ENGINE

CATEGORY 2.

ENGINE REAR MOUNTING AND REAR EXTENSION BRACKET.

Engine Rear Mounting.

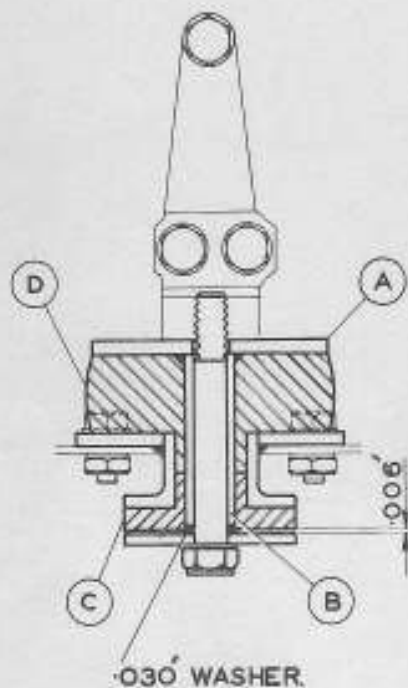
On certain vehicles it has been found that when the engine rear mounting bolt is fully tightened, the upper washer of the rear mounting distorts slightly to conical form, so that it seats only over an area close around the bolt hole in the undersurface of the bracket. This permits relative movement between the upper washer and the bracket, which may eventually cause fatigue failure of the engine mounting bolt at that point.

This is overcome by machining a counterbore in the undersurface of the rear extension bracket .750" in diameter and .005" - .010" deep, so that should the upper washer distort, the effective seating will not be confined close to the bolt hole, but to the diameter of the counterbore.

The rear engine mounting is also to be checked to ensure that the lower rebound rubber is not held tight but has .006" vertical clearance, when the assembly is tightened in position with the engine load on. If there is insufficient clearance a .030" thick steel washer is to be placed between the lower steel washer of the assembly, and the distance tube, taking care to ensure that the washer seats directly on the base of the distance tube, and does not foul the inside of the hole in the rebound rubber. Alternatively the distance tube can be lengthened .030" by welding and machining to a length of 2.045".

When the engine mounting bolt has been finally tightened, the rebound rubber should have a .006" minimum vertical clearance.
